**SUNDRY NOTICES AND REPORTS ON WELLS**  
*Do not use this form for proposals to drill or to re-enter an abandoned well. Use form 3160-3 (APD) for such proposals.*

8. Well Name and No.  
HICCUP A 1

Mustang Resources, LLC respectfully requests approval to plug and abandon the Hiccup A1. Please find attached pre- and post- wellbore diagrams, P&A procedure and cement calculations.

Re: Permanent Abandonment  
Well: Hiccup A1

# Hiccup A 1

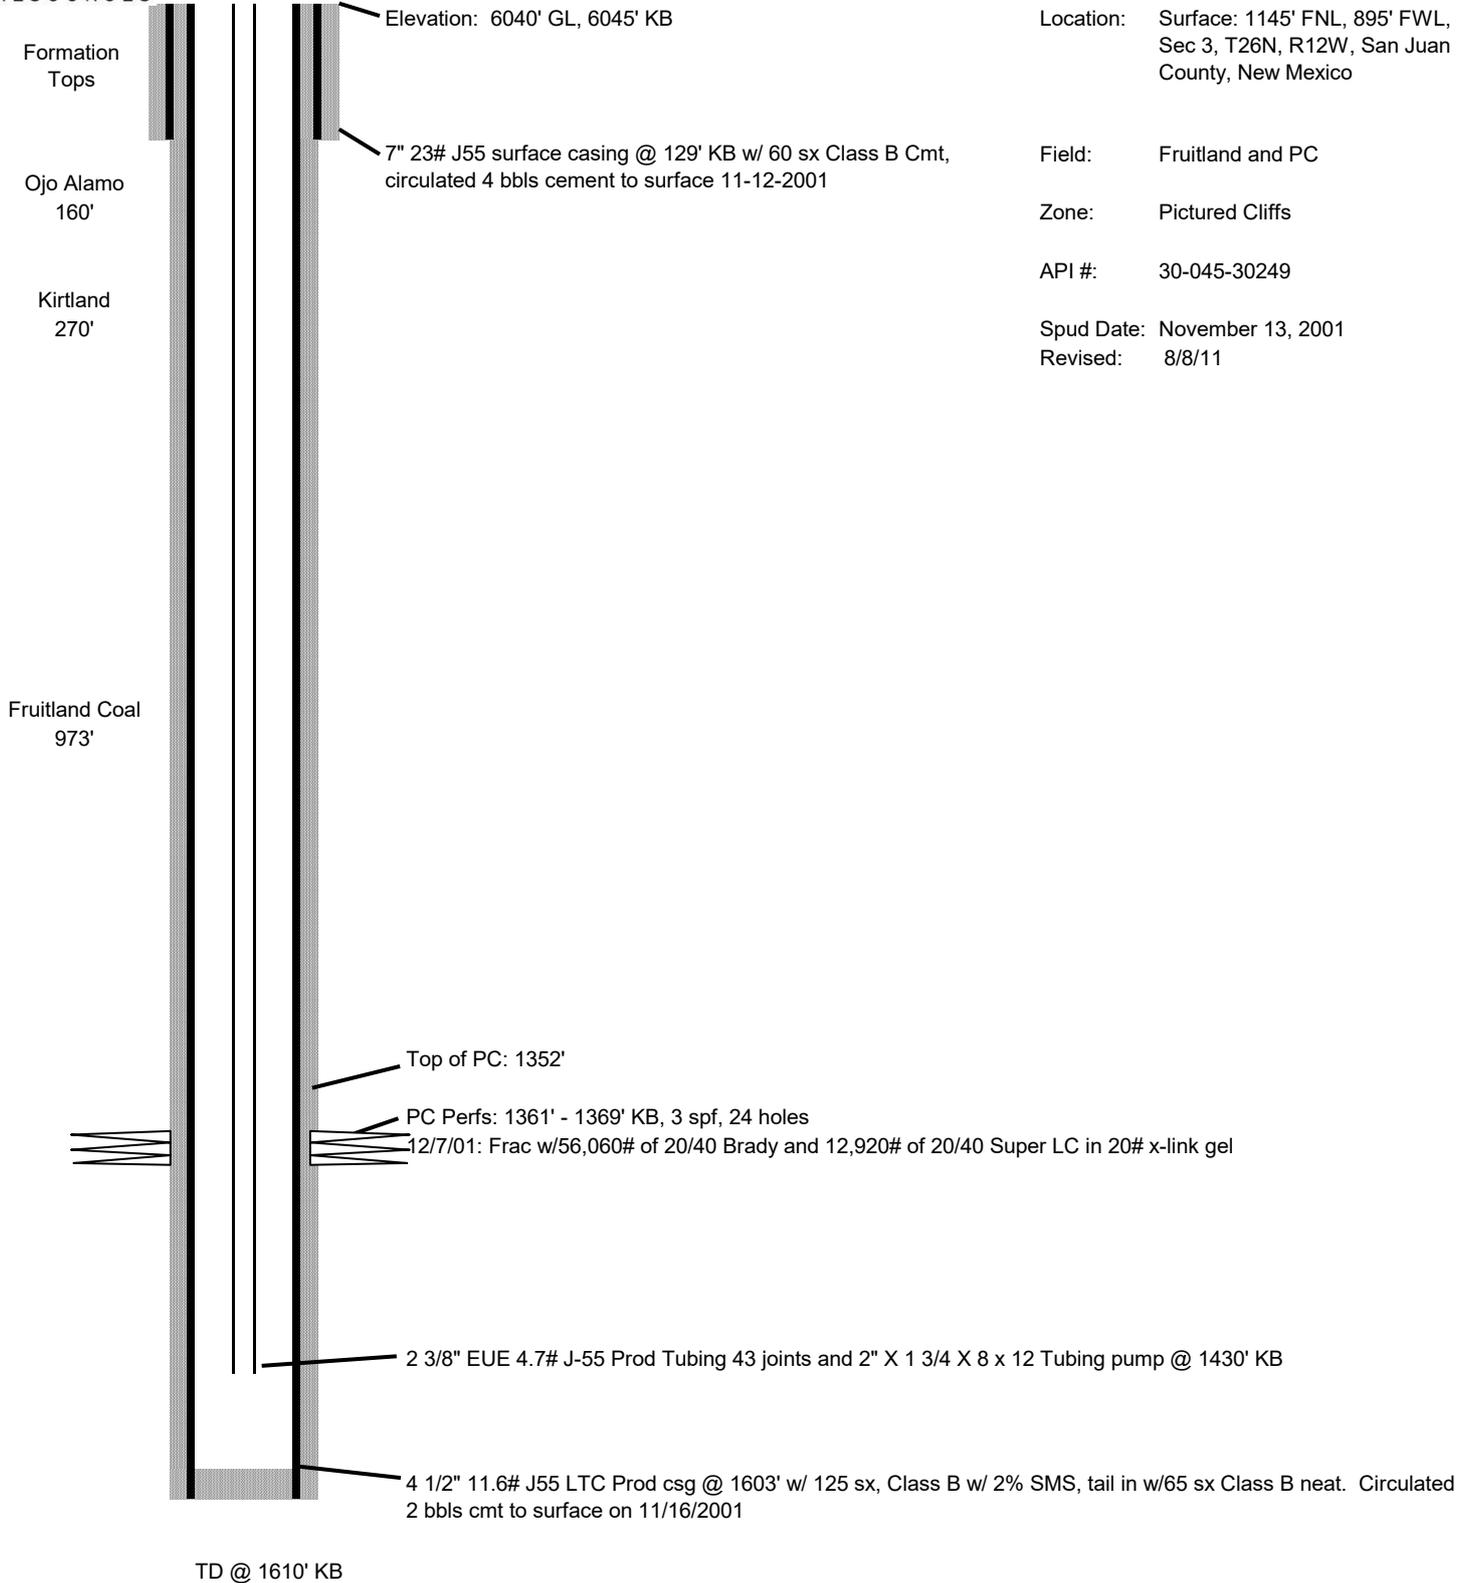
**\*\* BLM REVISED \*\* BLM REVISED \*\* BLM REVISED \*\* BLM REVISED \*\* BLM REVISED \*\***

**Plug 3 : Kirtland Top 270', Ojo Alamo Top 160', and Surface Top Off, with 2 3/8" tbg @ 320', establish circulation and place balanced plug mixing 24.3 sx (29.9 cf) cement plus 50% excess, pump until good cement to surface, TOH with 2 3/8" tbg and top off casing to surface.**

**Plug 2: Fruitland Coal Top 973', with 2 3/8" tbg @ 1023', establish circulation, place balanced plug 7.59 sx (8.73 cf) cement plus 50% excess, TOH to 320' and reverse hole clean.**

**Plug 1: Set CIBP at 1320', with 2 3/8" tbg @ 1315', establish circulation and place balanced plug mixing 7.59 sx (8.73 cf) cement plus 50% excess, TOH with 2 3/8" tbg to 1023' and reverse circulate hole clean.**

- Please ensure that the tops of the Pictured Cliffs and Fruitland formations as well as the entire Ojo Alamo aquifer, identified in this report, are isolated by proper placement of cement plugs. This will protect the freshwater sands in this well bore.
